Alterations to Gymnasium and Classroom Buildings at Burnt Ranch Elementary School Mold and Rehabilitation Project- Electric MSB- Bid Package 2018.4.5 Scope Clarification 2

BURNT RANCH ELEMENTARY SCHOOL
ALTERATIONS & ADDITION TO MULTI-PURPOSE
BUILDING/ CLASSROOM - INCREMENT 2

BID PACKAGE
CLARIFICATION

E0.2-I2

ELECTRICAL SITE PLAN 1 E0.2-I2
NTS

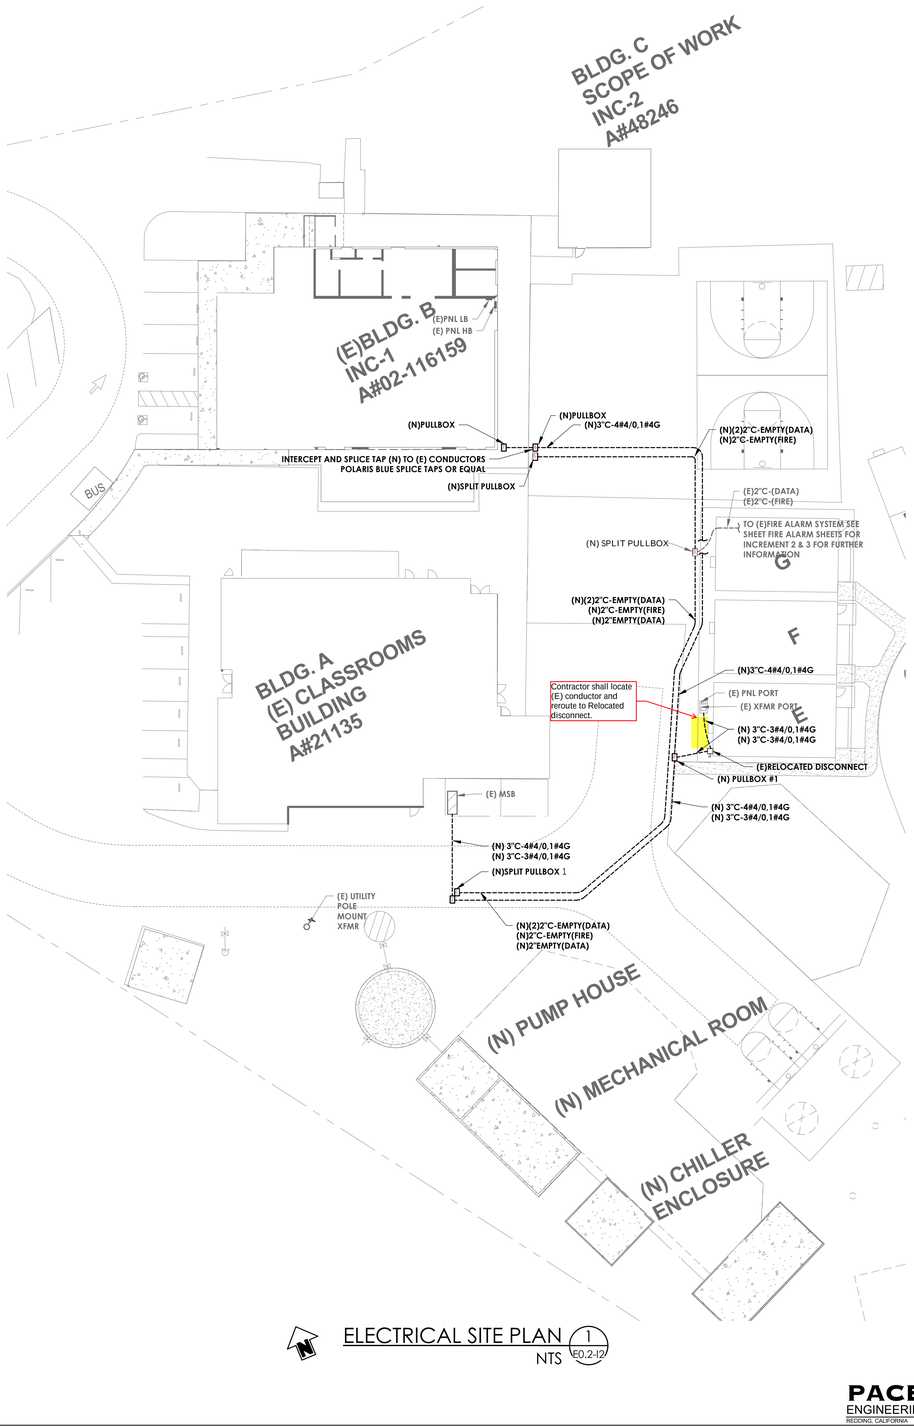
3. Relocate (E) Modular Disconnect (see pages 1,4 and 7 on attached pdf.)
   a. Contractor shall disconnect and relocate modular disconnect to location provided on site map.
   b. Contractor shall mount disconnect to the wall on the South West corner of Modular Building E using the existing brackets.

4. Modular Power (see pages 1,5,6 and 7 on attached pdf.)
   a. (E) Temp power to Modular buildings shall be abandoned. Contractor shall cut all (E) power conduit off at ground level and dispose of any conduit above ground. (E) Disconnect for Modular building shall be relocated.

b. Contractor shall reroute and connect temp power to modular buildings.
      i. Contractor shall trench and place -(N)3"C-3#4/0,1#4G from (E) MSB to Pull-Box 2.
      ii. Contractor shall trench and place -(N)3"C-3#4/0,1#4G from Pull-Box 2 to Pull-Box 4.
      iii. Contractor shall trench and place -(N) 3"C-3#4/0,1#4G from Pull-Box 4 to relocated Disconnect
      iv. Contractor shall locate (E) conduit powering (E) Modular Panel. Contractor shall run (E) power conductors back to disconnect through (N) conduit shown.

5. Gym Power (see pages 1,5,6,7,8,9 and 10 on attached pdf.)
   a. Contractor shall place (N)3"C-4#4/0,1#4G from (E)MSB to Pull-Box 2.
   b. Contractor shall place (N)3"C-4#4/0,1#4G from Pull-Box 2 to Pull-Box 4.

c. Contractor shall then trench and place (N)3"C-4#4/0,1#4G from Pull-Box 4 to Pull-Box 6.
   d. Contractor shall trench and place (N)3"C-4#4/0,1#4G From Pull-Box 6 to Pull Box 7.

e. Contractor shall place a sweep connected to (E)power to Gym into Pull-Box 7 and splice with the 4#4/0,1#4G conductor from Pull-Box 6.

6. Data (see pages 1,5,6,7,8,9 and 10 on attached pdf.)
   a. Contractor shall trench and place (3) 2" conduits from Pull-Box 1 to Pull-Box 3.
   b. Contractor shall trench and place (2) 2" conduit from Pull-Box 3 to Pull-Box 5.

7. Fire Alarm (see pages 1,5,6,7,8,9 and 10 on attached pdf.)
a. Contractor shall trench and place (1) 2" conduit from Pull-Box 1 to Pull-Box 3.
b. Contractor shall trench and place (1) 2" conduit from Pull-Box 3 to Pull-Box 5.

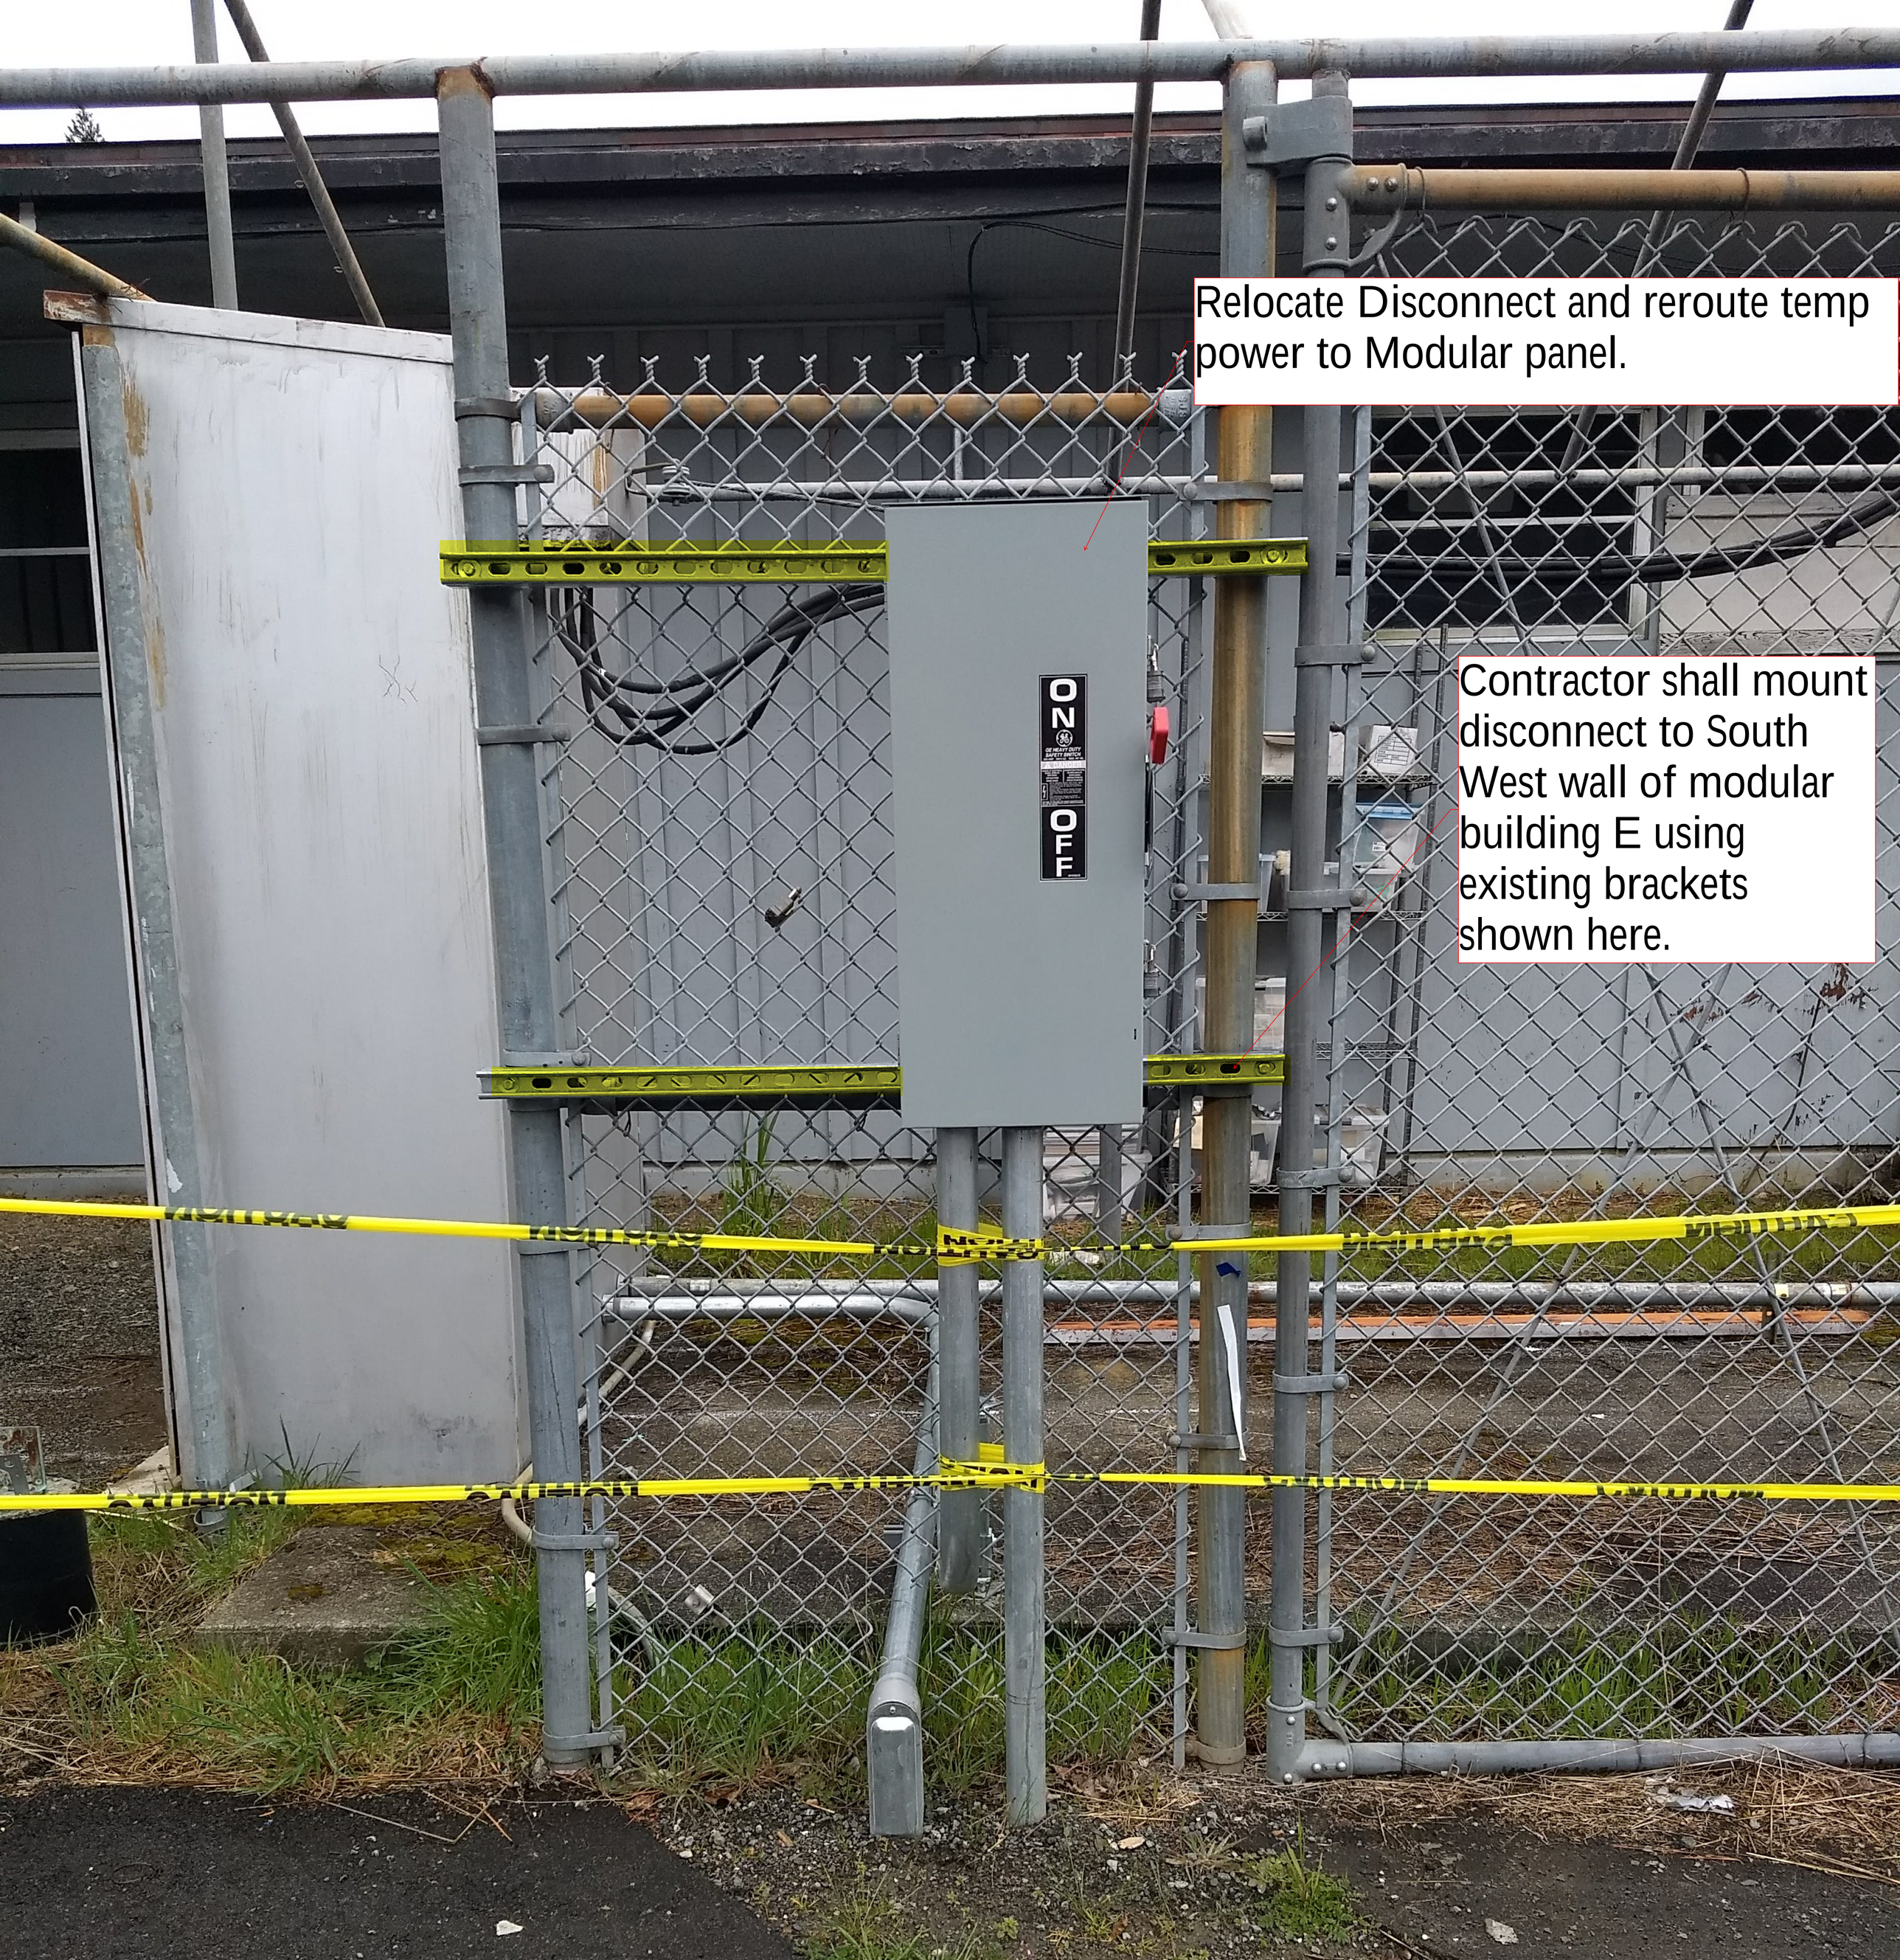
Relocate Disconnect and reroute temp power to Modular panel.
Contractor shall mount disconnect to South West wall of modular building E using existing brackets shown here.
ON
GE HEAVY DUTY SAFETY SWITCH
OFF

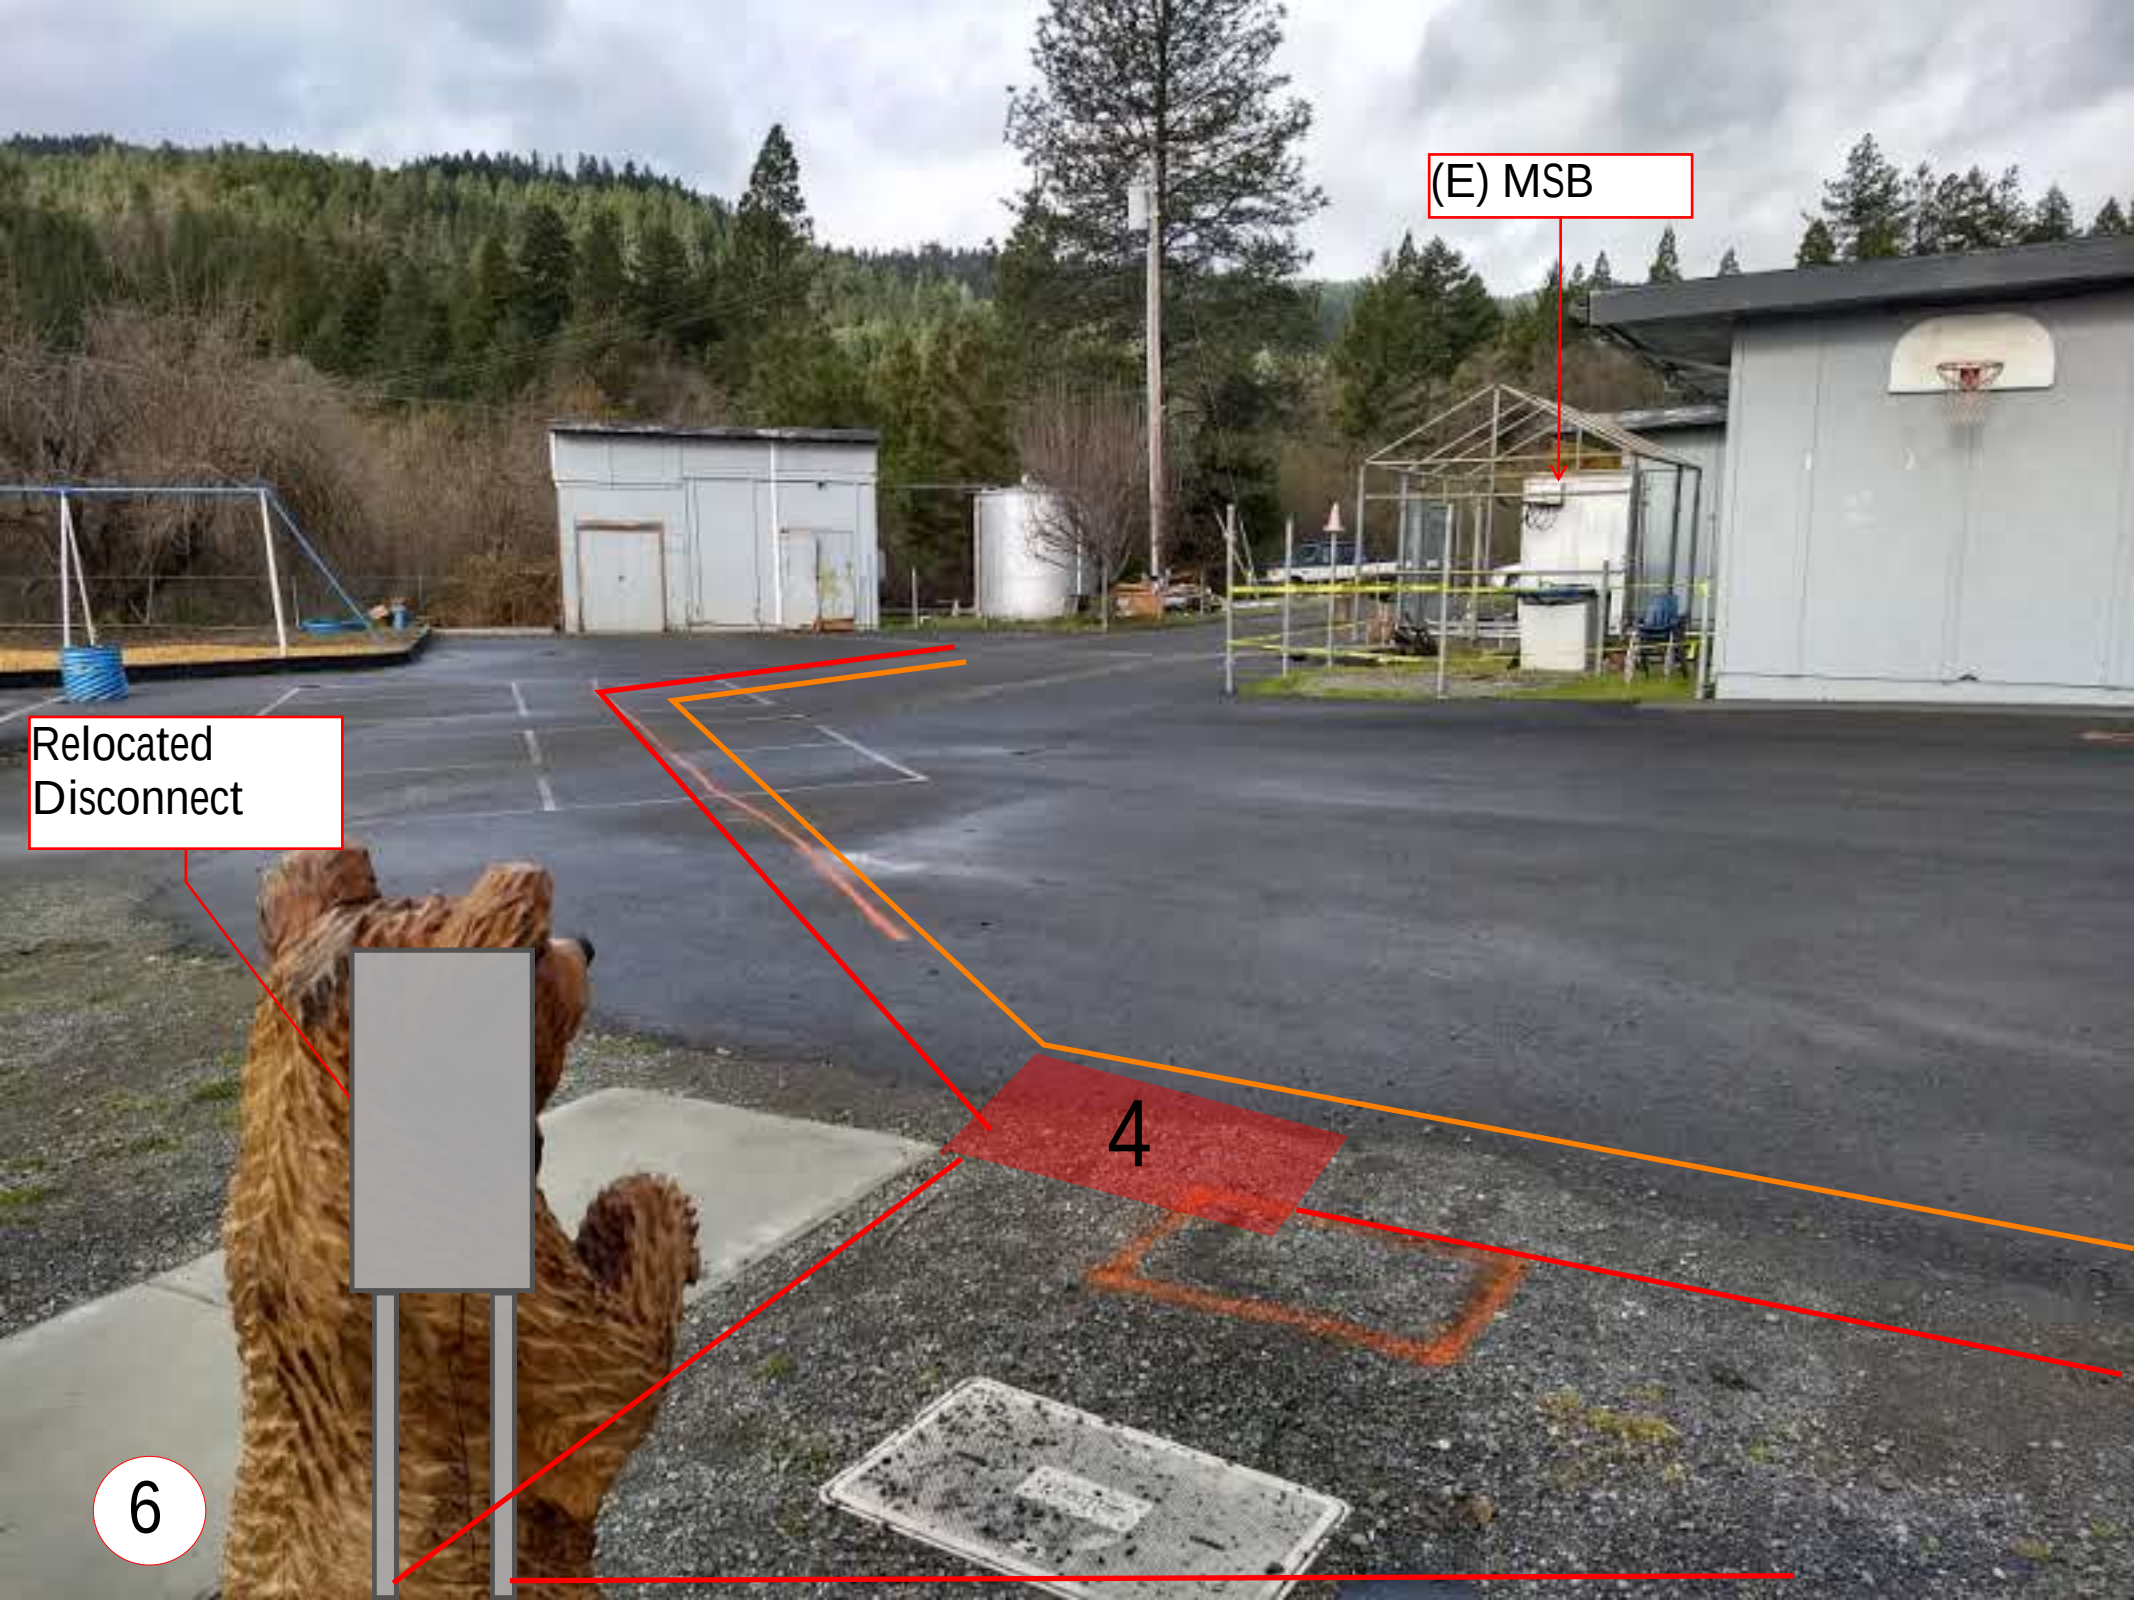
Relocate Disconnect here.
Contractor shall locate (E) Conductor and reroute to Relocated disconnect.
(E) C-3#4/0,1#4G
(N) 3"C-3#4/0,1#4G
3
4
7
